Date	18 <sup>th</sup> February 2026	Issued version	2.0
Author	Ryan Smith, CBEC Eco-engineering UK Ltd		
Technical & Comm. Reviewer	Leonardo Camelo, CBEC Eco-engineering UK Ltd		
To	Gabriel Connor-Streich, Greenshank Environmental		
Project	2150779 – Stodmarsh Stream Enhancement Scheme		
Subject	Design Method Statement – Bliby Wood (Long) and Hinxhill_DD1

**Table 1.1 Summary of clarifications added to this version of the Method Statement**

**Figure 4-1 Bliby Wood Spoil Disposal**

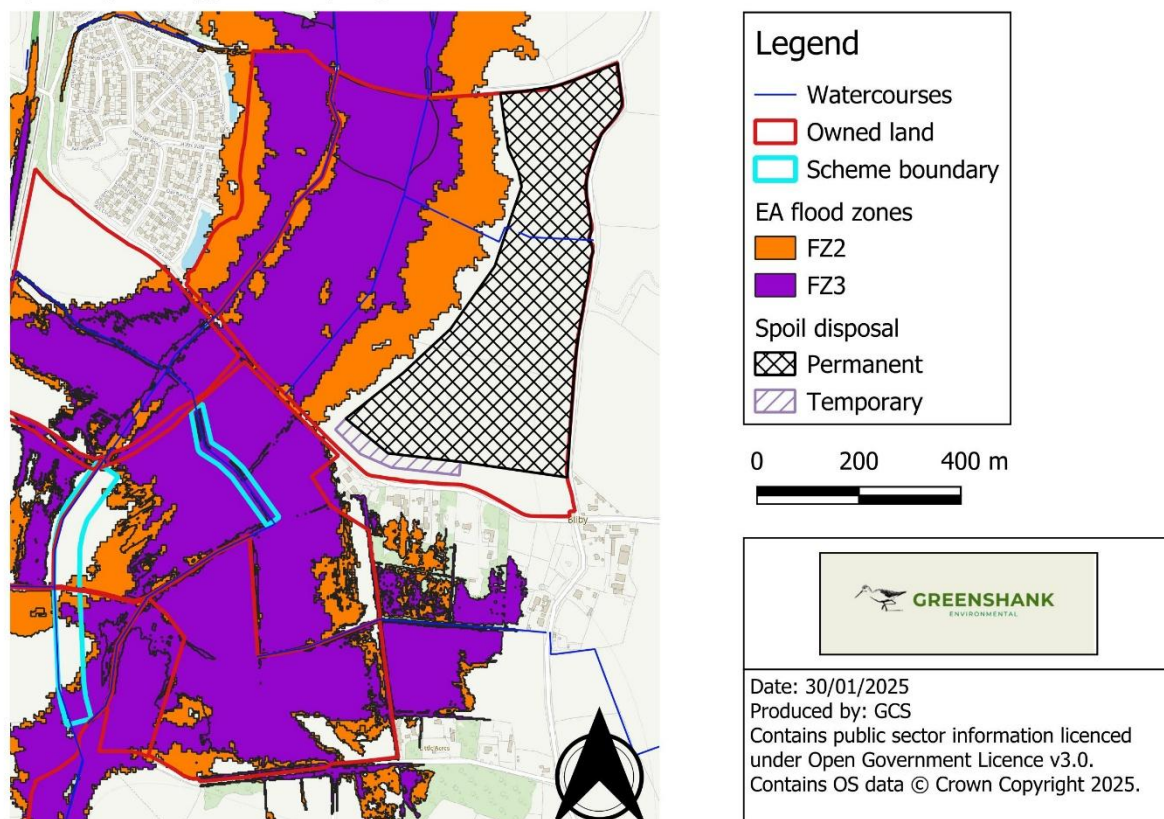
Provide clarity around spoil disposal locations	<b>Section 4.3</b>	A supplementary map has been provided by Greenshank Environmental, showing the locations of spoil disposal outside of flood zones. A statement has been added noting the location and that this outside of flood zone 2 and 3.
Clarify process for temporary spoil storage	<b>Section 4.5</b>	Statement added regarding temporary spoil storage within the floodplain and where most temporary spoil storage will be located.

Creating the new two-stage channels will produce a large amount of spoil. To keep the scheme cost-effective and sustainable, materials should be used onsite to avoid both the financial and carbon costs of transporting material offsite. The main reuse of material will be to fill the existing channels. Any surplus material can also be used to regrade the floodplain benches and channel margins, ensuring smooth transitions between new and existing surfaces. Where surplus material needs to be transported offsite, the landowner has agreed to use exclusively areas of land that are not in Flood Zone 2 or 3. A supplementary map has been provided by Greenshank Environmental (Figure 4.1) that shows the locations of both temporary and permanent spoil disposal. Both temporary and permanent disposal will utilise Flood Zone 1 areas under the landowner's control.

During the excavation of the two-stage channel within the right floodplain, the excavated material will be stored in a 'live' stockpile within the floodplain. Live stockpiles will be removed on the day of deposition to a temporary spoil disposal location, as shown in the spoil disposal supplementary map. The contractor is also likely to move most spoil directly to the temporary disposal location, minimising the size of any live stockpiles within the floodplain. It is recommended that silt wattles be staked to the ground surrounding any stockpiles to mitigate potential sediment runoff during heavy rainfall.
